City of Detroit
Inter-Departmental Communication

RE: Petition No. 639
Request to Encroach Into Baltimore St. at 207 East Baltimore St. with a Canopy,
Wall Sconces and Lighting

**REQUEST ENCROACHMENT
 INTO E. BALTIMORE
 AT 207 E. BALTIMORE**
 (With Canopy, Wall Sconces & Uplighting)

PROVISIONS FOR ENCROACHMENT For Petition 639

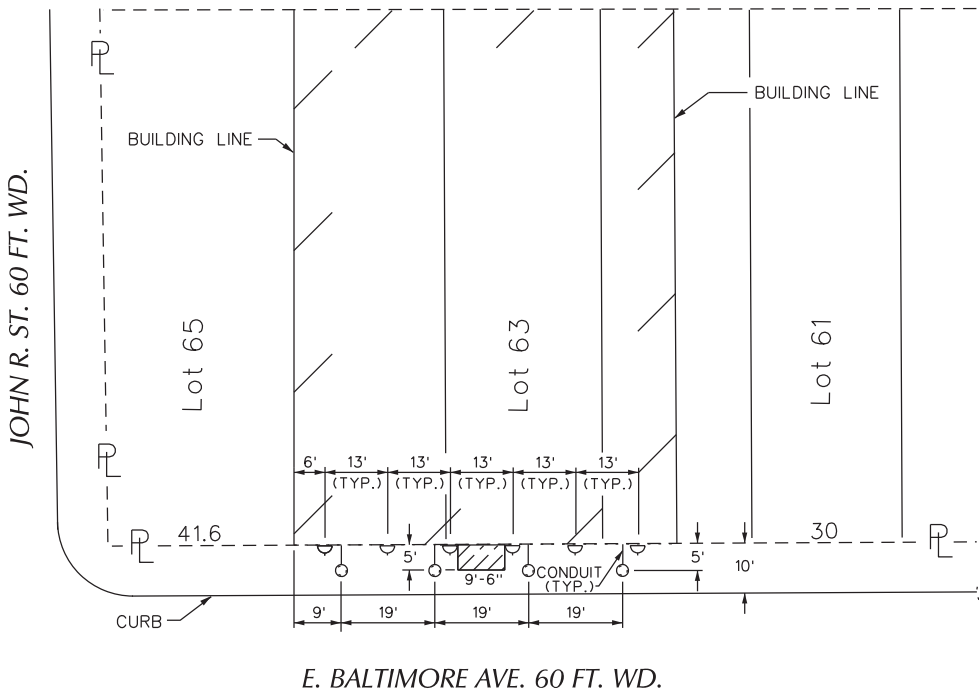
- Our records indicate that there is a water main in Baltimore St. DWSD has no objections to the encroachment, if the petitioner agrees to follow the terms stated in the attached Provisions for Encroachment.
